ADDENDUM NUMBER: TWO

PROJECT: New Field House – Northern Nash High School
4230 Green Hills Road
Rocky Mount, North Carolina 27804

PROJECT NO: 21038

DATE: May 17, 2023

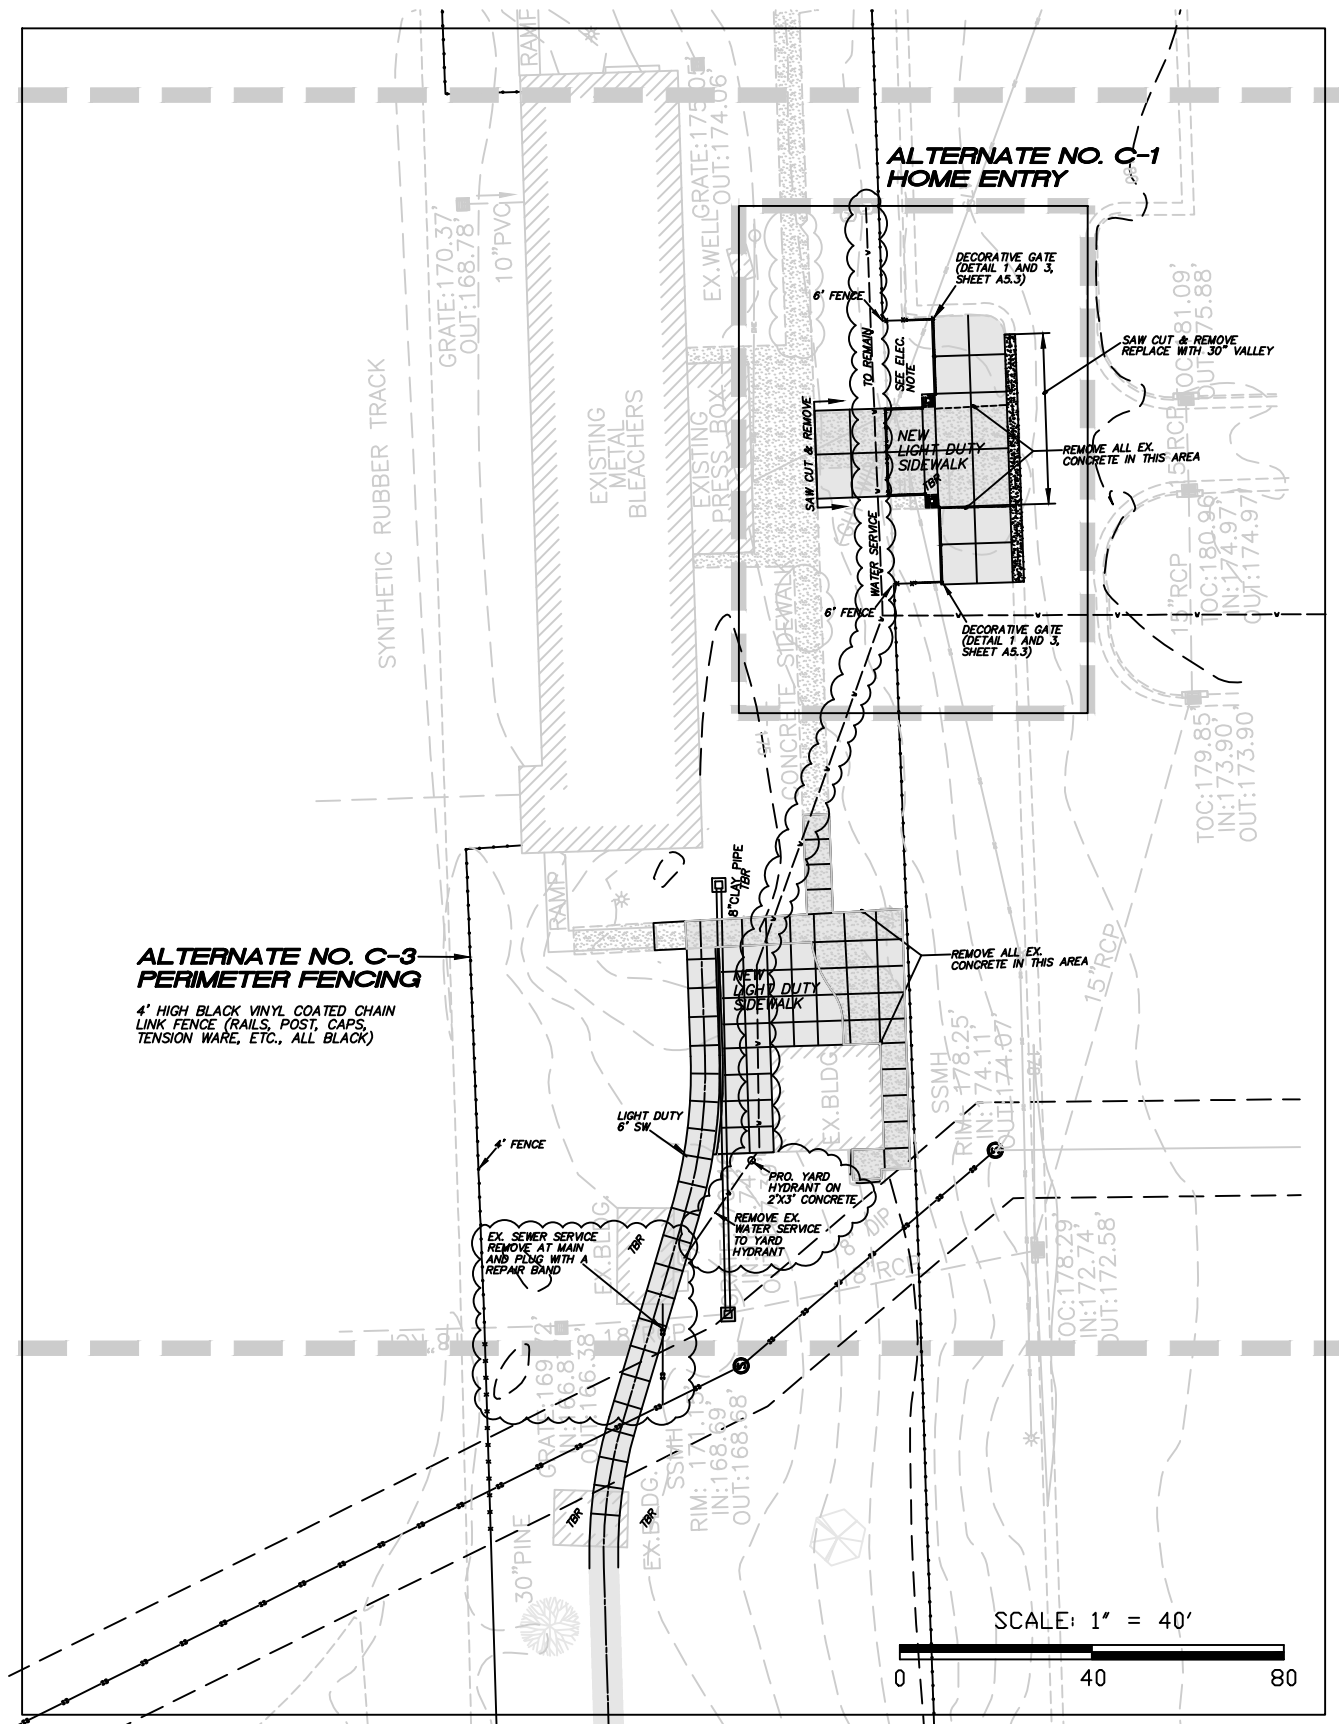
- Item 1 Clarification** **BD-1 (Reference Sheet – CE-04)**
Remove existing water and sanitary sewer as indicated on this sketch for existing buildings being demolished and noted TBR on civil plan set.

Date 4-24-23	Project No. 21038
Drawn By DEW	Sheet No. M1.1
Checked By DWP	Sheet Title MECHANICAL PLAN

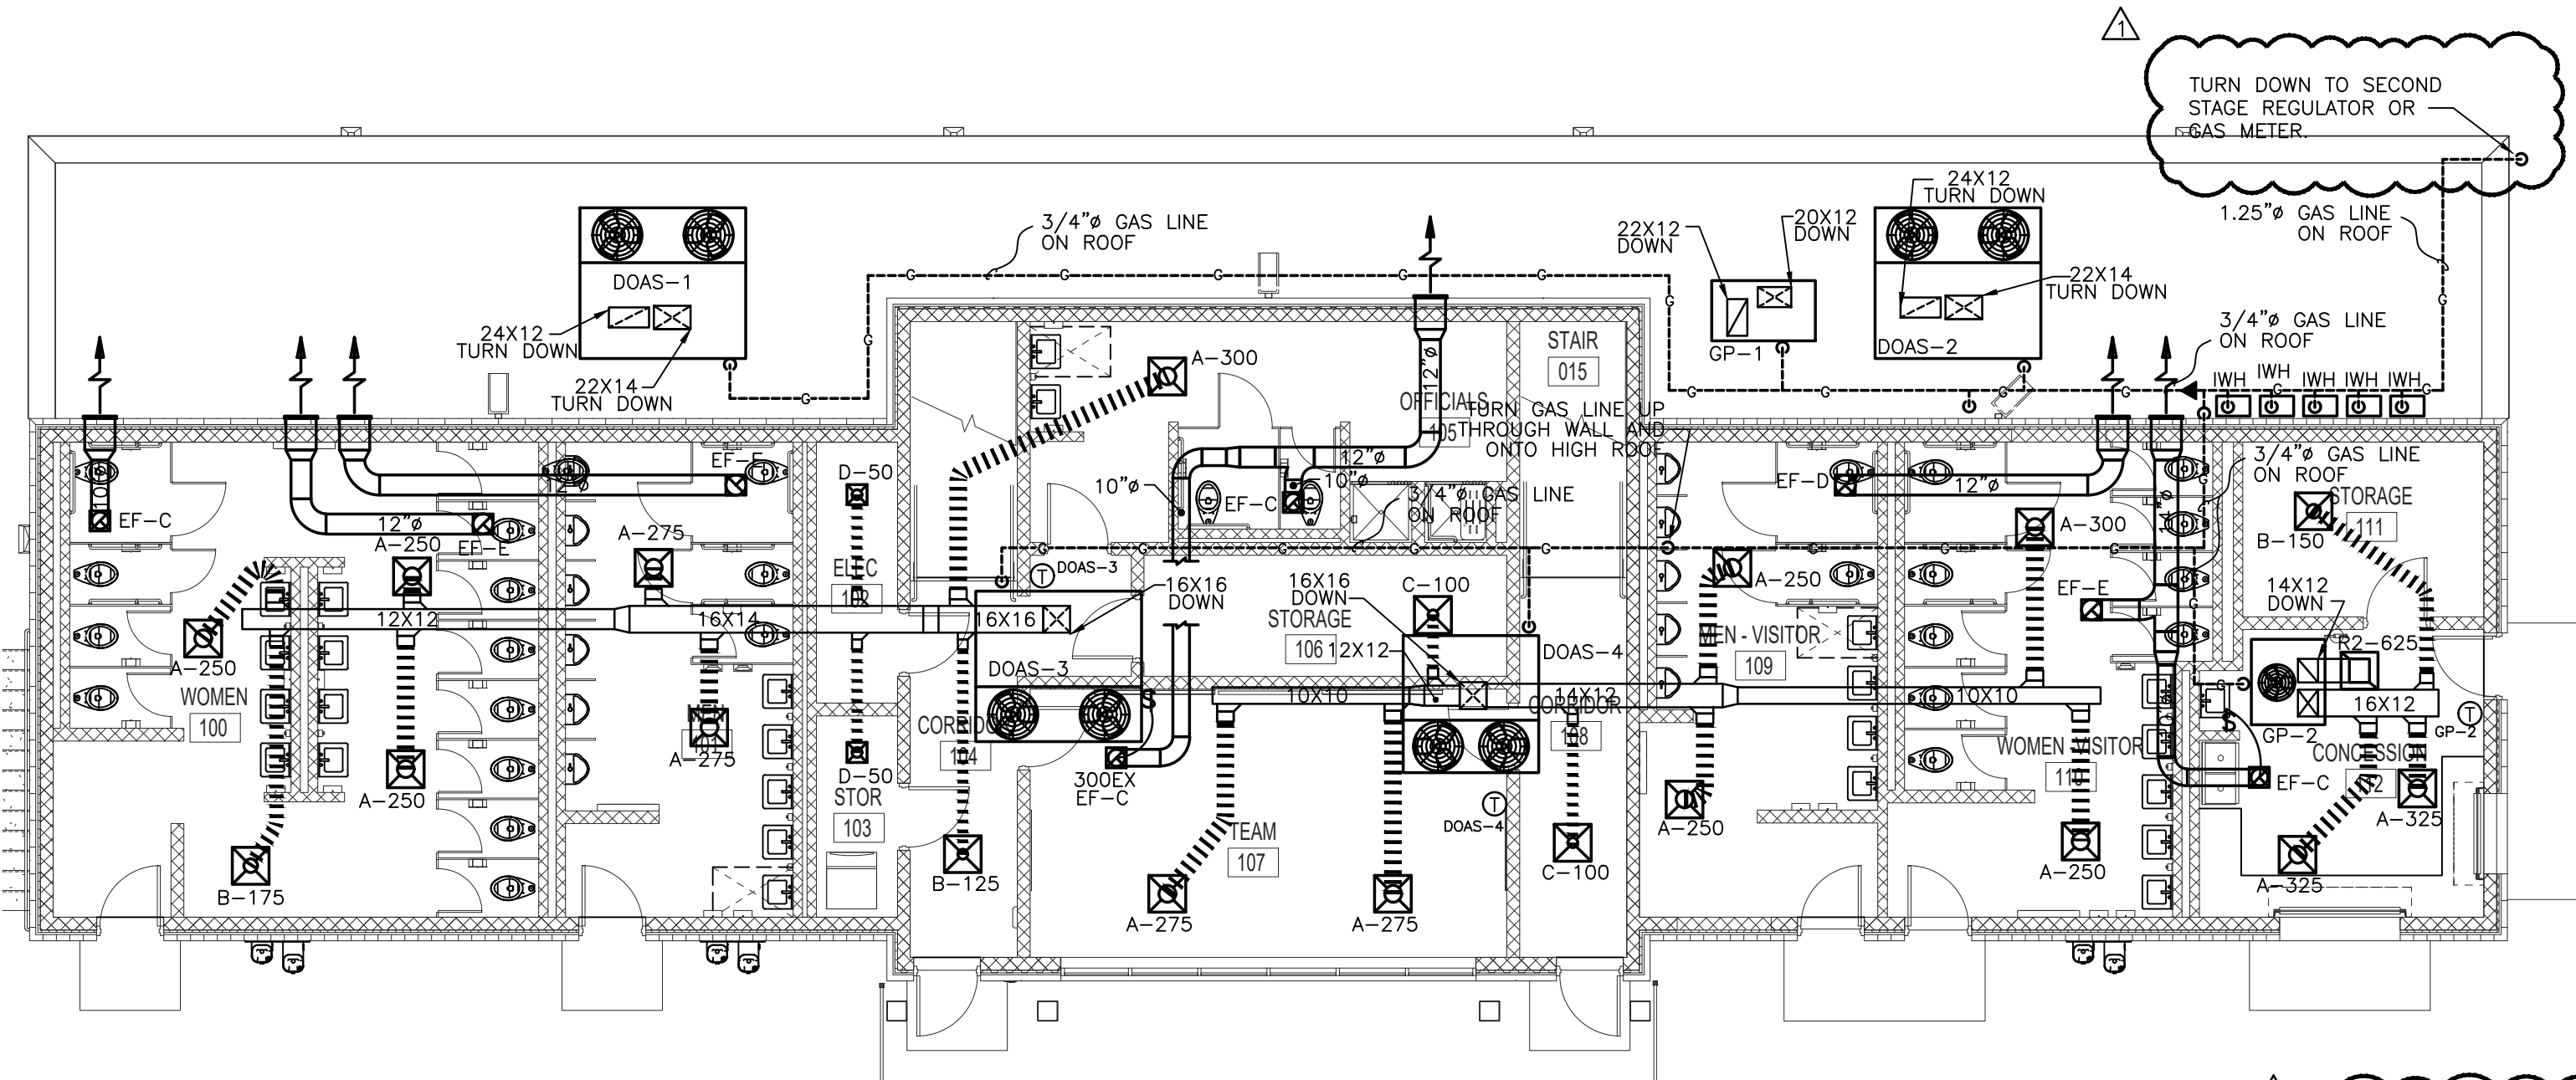
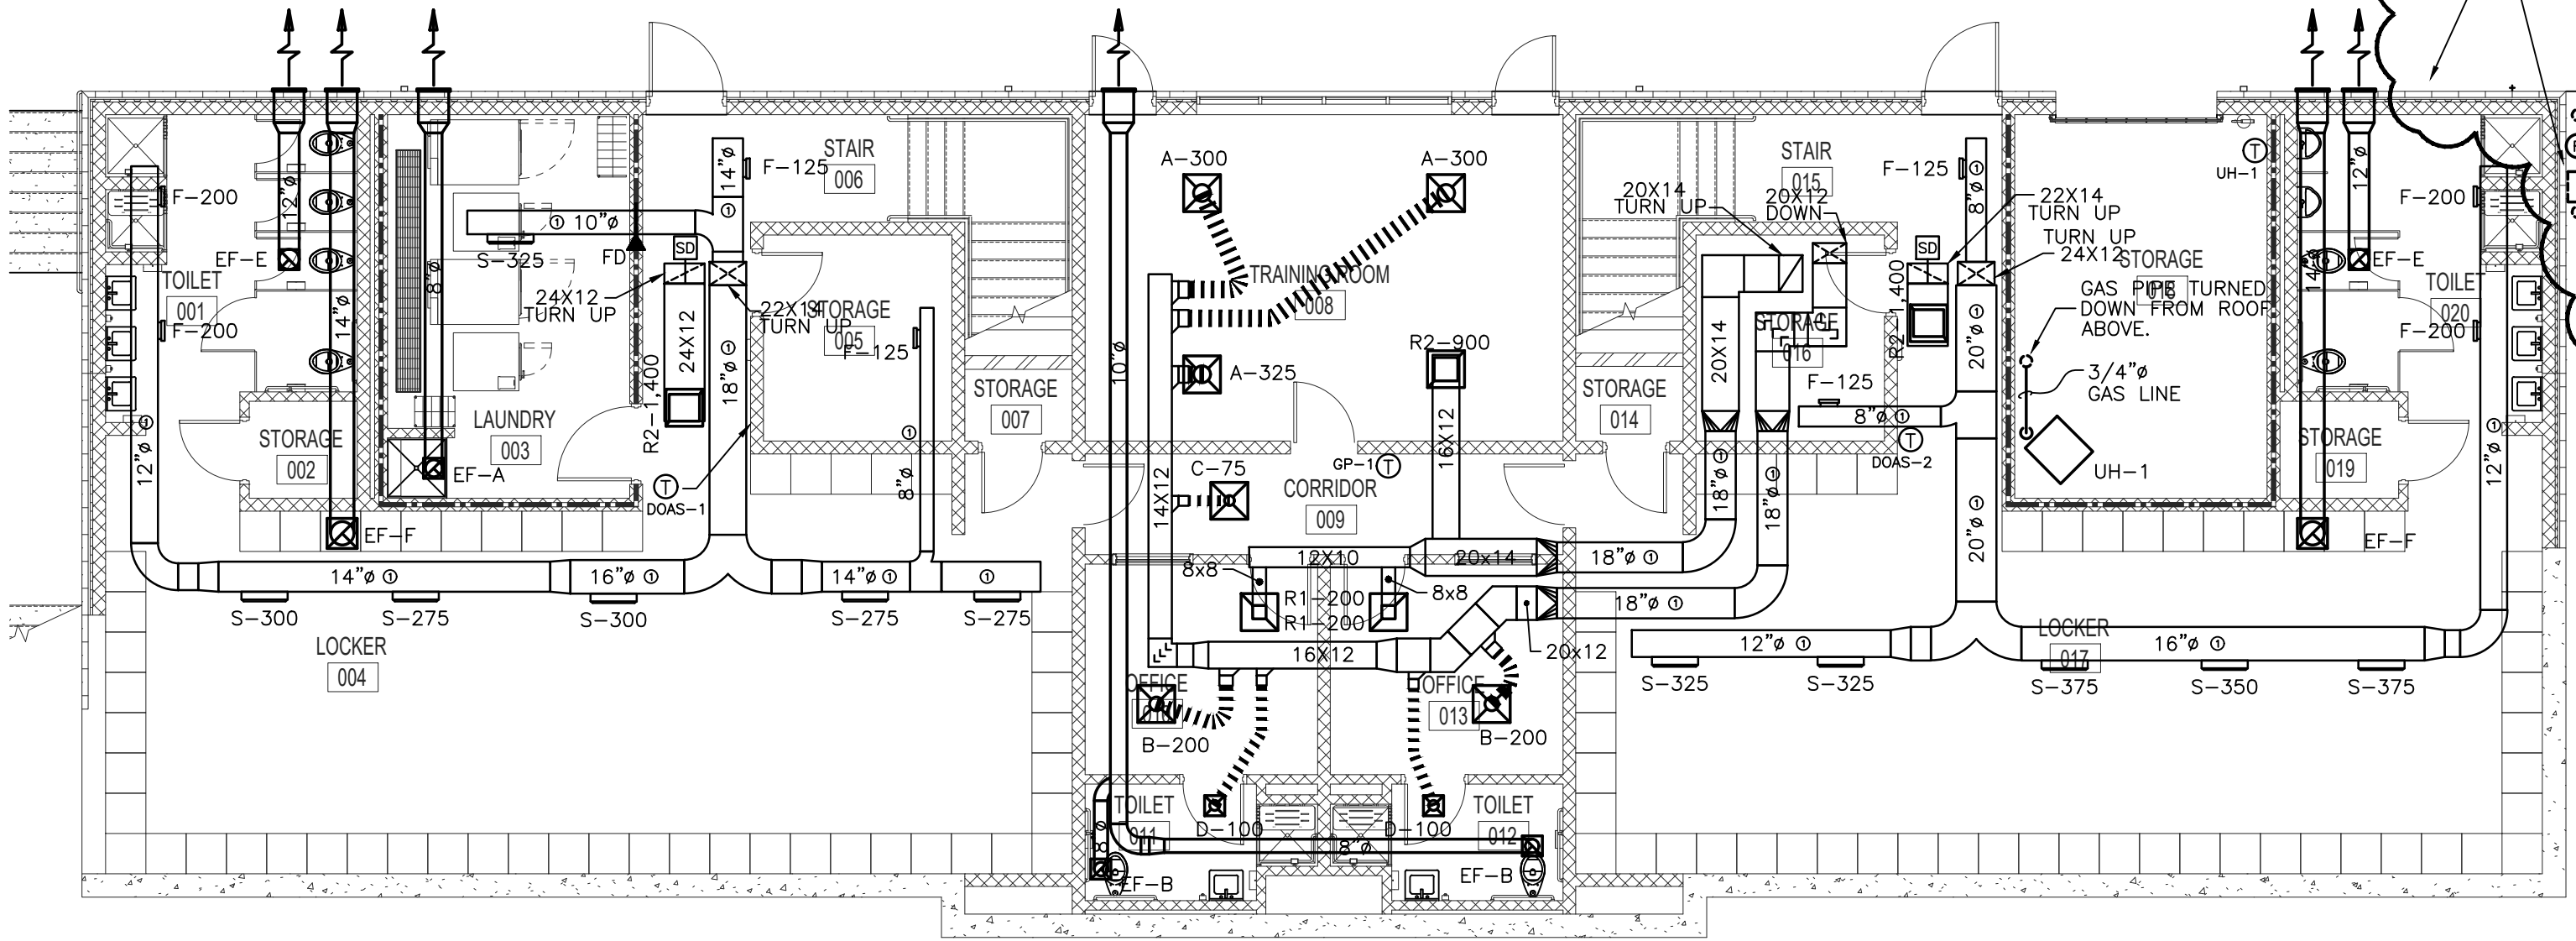
- Item 4 Change** **Sheet M1.1**
Remove the existing sheet in its entirety and replace it with the attached sheet – Removed propane regulator and added natural gas meter location and notes, added note for Contractor to provide secondary regulators for all gas fired equipment.

NOTE: MECHANICAL CONTRACTOR SHALL PROVIDE SECOND STAGE REGULATORS AS REQUIRED FOR ALL GAS FIRED EQUIPMENT. COORDINATE REQUIREMENTS WITH ALL GAS FIRED EQUIPMENT.
